DEVELOPMENT HEARING OFFICER

PR-2019-002668

SD-2024-00124 – PRELIMINARY/FINAL PLAT
IDO – 2024

REQUEST: Create Lot 28-A-1-A & 28-A-1-B to dedicate 28-A-1-B to AMAFCA in fee simple per agreement between owner and AMAFCA. Lot 28-A-1-B contains AMAFCA's existing concrete channel and facilities

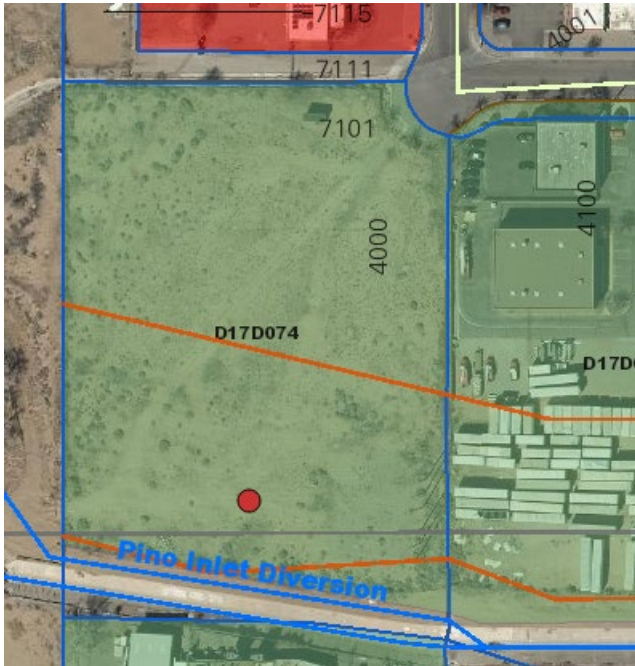
- Clarify and confirm if the easement in orange is still active and if it will affect this request.
